**PLANNED UNIT DEVELOPMENT
& SUBDIVISION STAFF REPORT****Date: November 16, 2006****DEVELOPMENT NAME**

White Smith Subdivision

Planned Unit Development Approval to allow two single-family residential condominium buildings on a single building site.

SITE PLAN

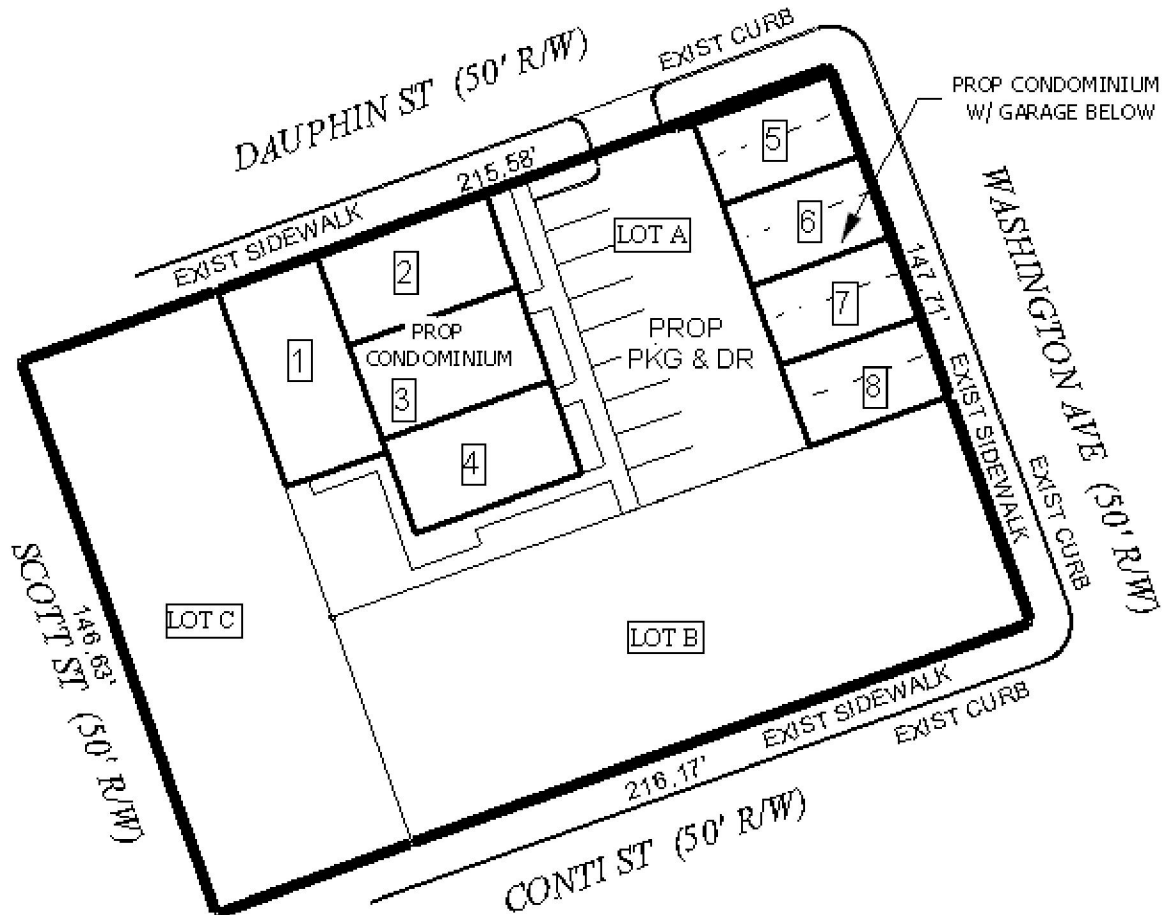
Parking for residential development within the Henry Aaron Loop is not required, however, the site plan depicts 17 parking spaces. It should be pointed out that the two parking spaces nearest the southern property line do not appear to have sufficient area to back out and turn, thus these spaces may prove problematic in actual use.

No trees or landscaping are depicted on the site plan, however compliance to the greatest extent feasible with the tree and landscaping aspect of the Zoning Ordinance will be required. The site plan should be revised to reflect proposed landscaping and any existing or proposed street trees, and compliance with the Zoning Ordinance should be coordinated with Urban Forestry. It should be noted that the urban nature of the site and the allowed 100% site coverage in a B-4 zoning district may make full compliance with the tree and landscaping requirements impossible.

There is no indication on the site plan as to the proposed location of any dumpster or other waste storage facility. The location of the storage area for the dumpster must be indicated on the site plan, and the location and required screening must comply Section 64-4.D.9. of the Zoning Ordinance, as well as with all other applicable regulations.

Planned Unit Development: Based on the preceding, this application is recommended for Approval, subject to the following conditions: 1) revision of the site plan to depict compliance, to the greatest extent feasible, with the tree and landscaping requirements of the Zoning Ordinance, to be coordinated with Urban Forestry; 2) revision of the site plan to depict any existing or proposed street trees, with proposed street trees to be coordinated with Urban Forestry; 3) depiction of any dumpster or waste container storage location on the site plan; 4) approval of Traffic Engineering regarding the size, design and location of the curb-cut onto Dauphin Street; 5) placement of a note on the site plan stating that PUD approval is site plan specific, and requires Planning Commission approval for changes to the approved site plan; 6) provision of a revised site plan to the Planning Section of Urban Development prior to the signing and recording of the final plat; 7) completion of the Subdivision process; and 8) full compliance, to the greatest extent possible, with all other municipal codes and ordinances.

Subdivision: With waivers of Section V.D.6. and V.D.9. of the Subdivision Regulations, this application is recommended for Tentative Approval, subject to the following conditions: 1) The site should be limited to the existing number of curb-cuts along each street [Lot A - one curb-cut (Dauphin Street), Lot B - one curb-cut (Conti Street), and Lot C - two curb-cuts (Scott Street)], with any changes to the size, design and location of the curb-cuts to be approved by Traffic Engineering and, where possible, conform to AASHTO standards; 2) labeling of each lot with its size in square feet, or provision of a table on the plat with the same information; 3) provision of a revised PUD site plan to the Planning Section of Urban Development, prior to the signing and recording of the final plat; and 4) full compliance, to the greatest extent possible, with all other municipal codes and ordinances.
